Contract Change Order No 4

Project Number: 90.19004

Project Name: City Hall Interior Renovation Project

SIGNAL HILL CITY HALL
 STEEL WINDOW REPLACEMENT
 2175 CHERRY AVE
 SIGNAL HILL, CALIFORNIA 90755

A STEEL WINDOW @ DAMAGED HEAD - 3RD FLR.
A-604 Scale: Half Actual Size

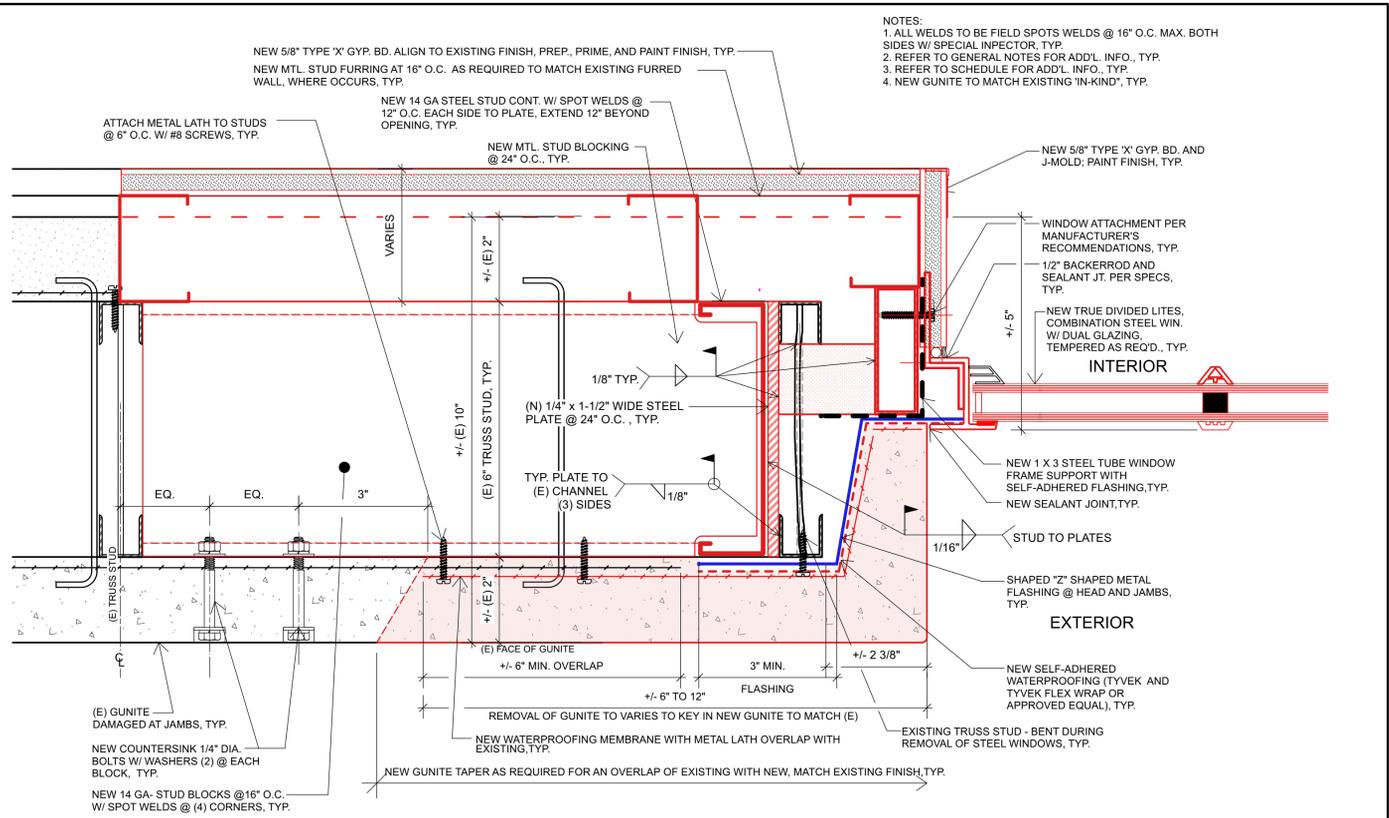
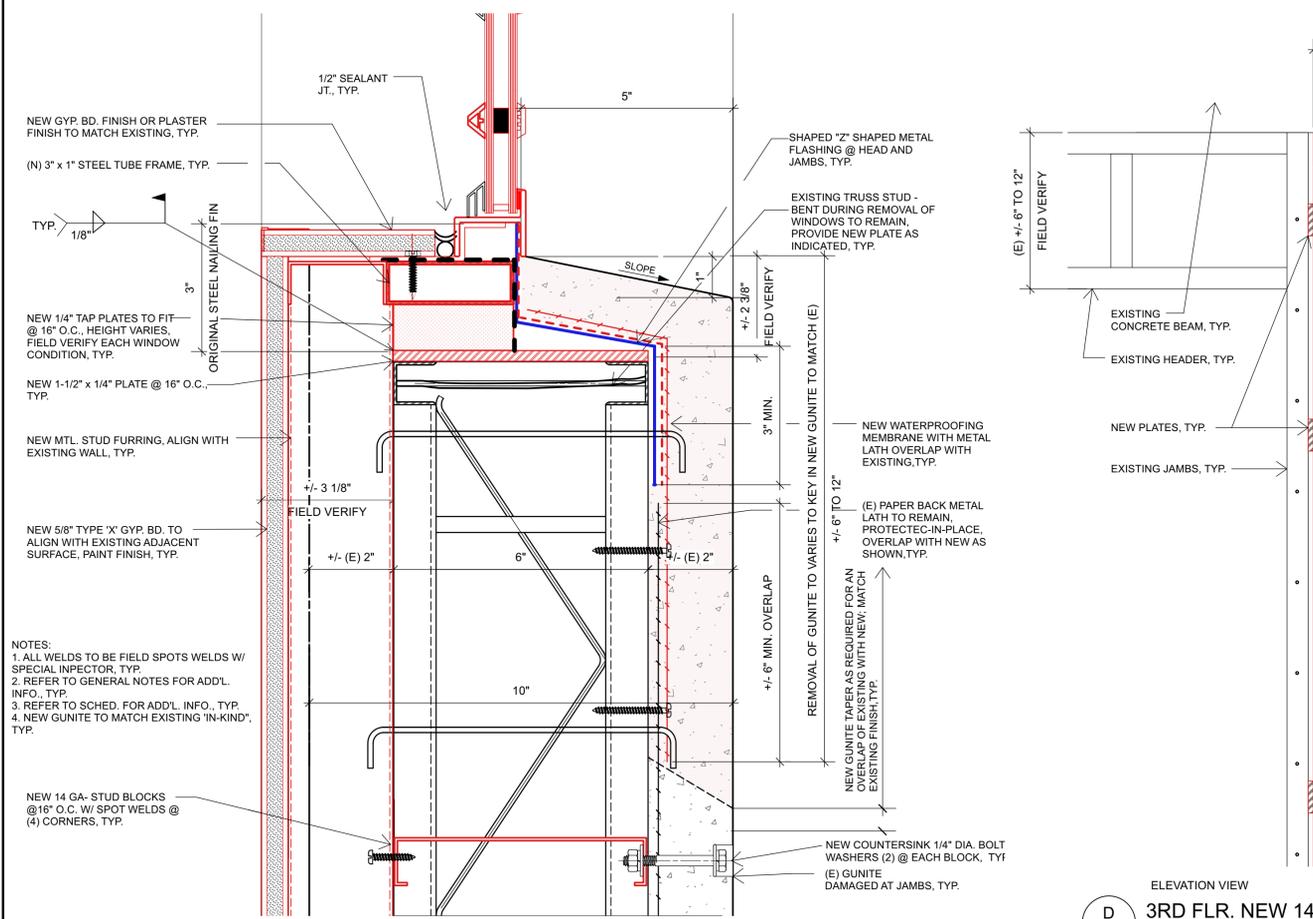
- REPAIRING OF TRUSS STUD WEBBING:**
- REFER TO DETAIL B/A-604 FOR REPAIRING OF TRUSS STUD WEBBING. STEEL PLATES SHALL BE ADDED PER DETAIL ALONG WITH 14 GA. STUD AND BLOCKING AT 24" O.C.
 - PROVIDE SPECIAL INSPECTIONS FOR ALL FIELD WELDING AS NOTED IN GENERAL NOTES 6B, TYP. SUBMIT DOCUMENTATION TO STRUCTURAL ENGINEER FOR REVIEW
 - FOR ADDITIONAL REPAIR INFO. REFER TO DETAIL D/A-604 FOR RETROFITTING DAMAGED TRUSS STUD WEBBING IN THE FIELD.

A.1 STEEL WINDOW @ DAMAGED HEAD - 3RD FLR.
A-605 Scale: Half Actual Size

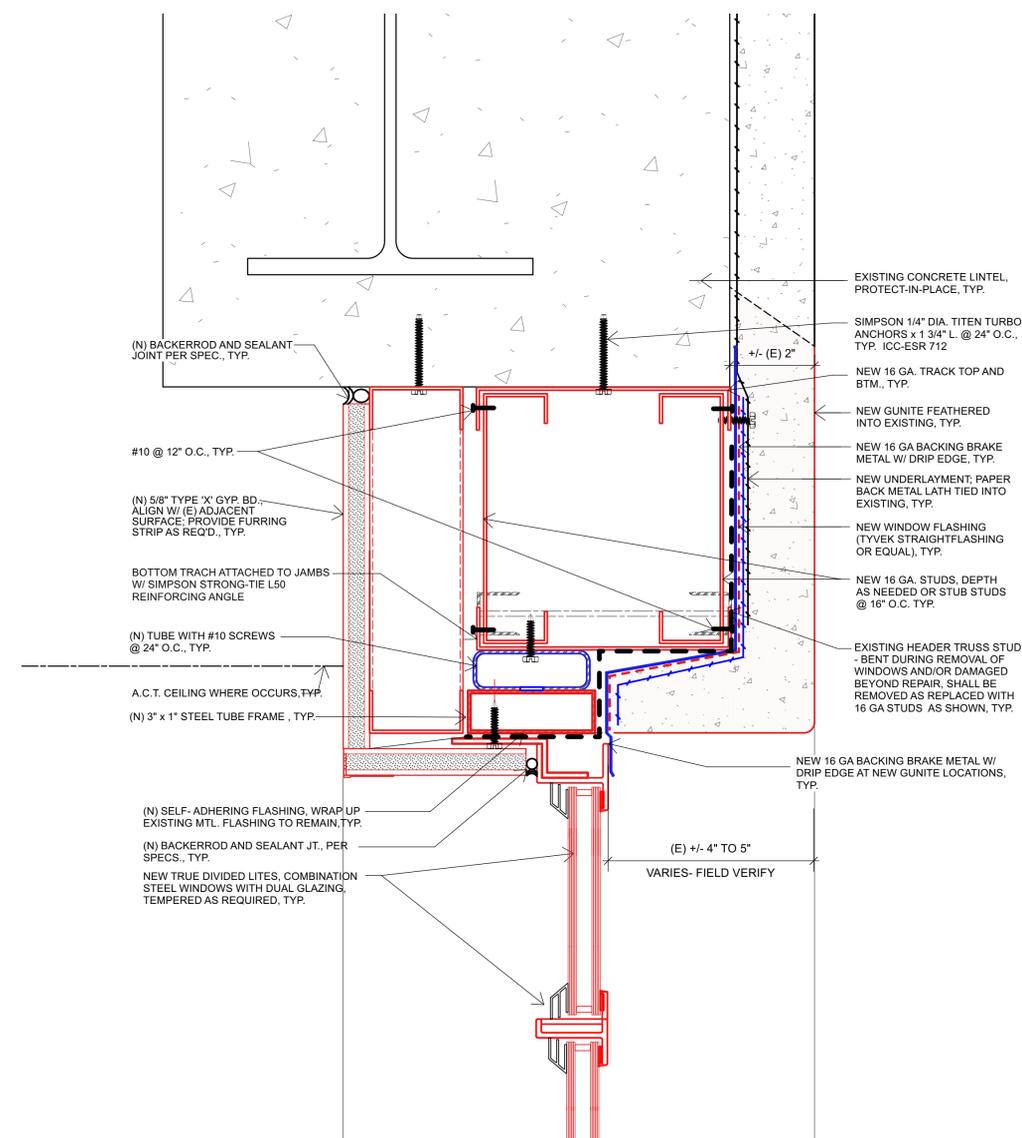
ALTERNATIVE DETAIL FOR REPLACEMENT OF DAMAGED FRAMING BEYOND REPAIR AT HEADER
